Reference 11575 R02v1

Project Galston Aquatic & Leisure Centre

**Re: Addressing Hornsby Shire Council Concerns**

**Figure 1 Site Location and Surrounds**

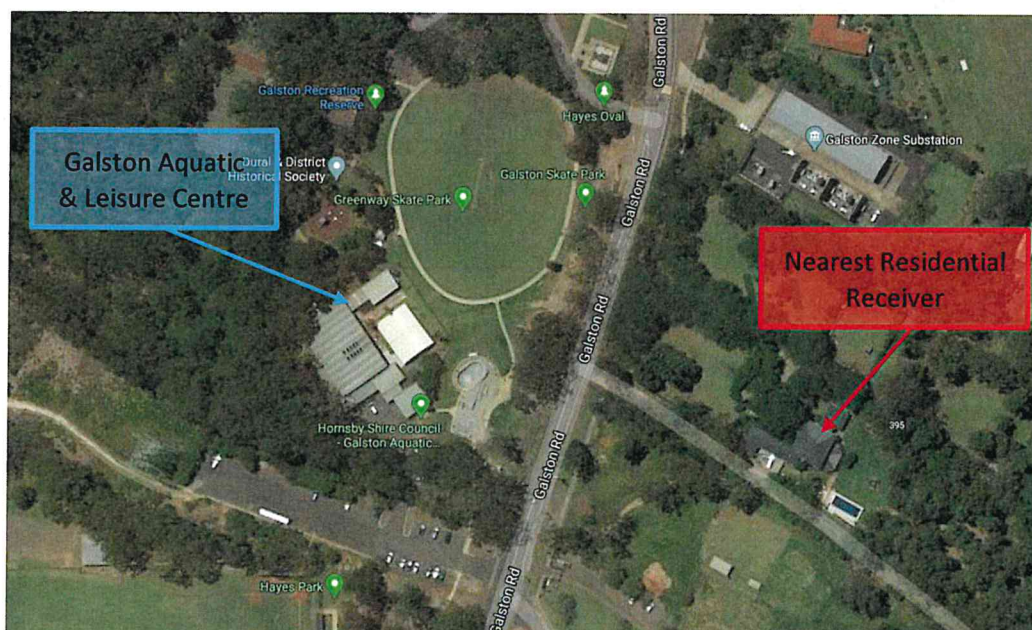
*Council has also assessed the Preliminary Acoustic Report which solely addresses the internal reverberation within the main pool area. Whilst Council is aware that the Galston Aquatic Centre is located away from close proximity to residential receivers, Council notes there is one property located to the east across Galston Road that Council cannot be certain will not be affected by the new acoustic roof installation. Council would be satisfied if a statement is provided by a qualified acoustic consultant to confirm that noise from the pool and new roof will not exceed 5 dBA above background at the closest residential receiver being 395 Galston Road, Galston.*

As the proposed acoustic roof is absorptive in nature (decreases noise levels), and will be enclosing the currently outdoor pool, the overall noise levels experienced by the nearest residential receiver will be reduced compared to the current noise from the site. Furthermore, PKA understands that the siting and position of the mechanical plant rooms are to be shielded from the residences located at 395 Galston Rd by the GALC's building.

As such, we confirm that the noise from the pool and new roof will not exceed 5 dB(A) above the background noise level at the nearest residential receiver.
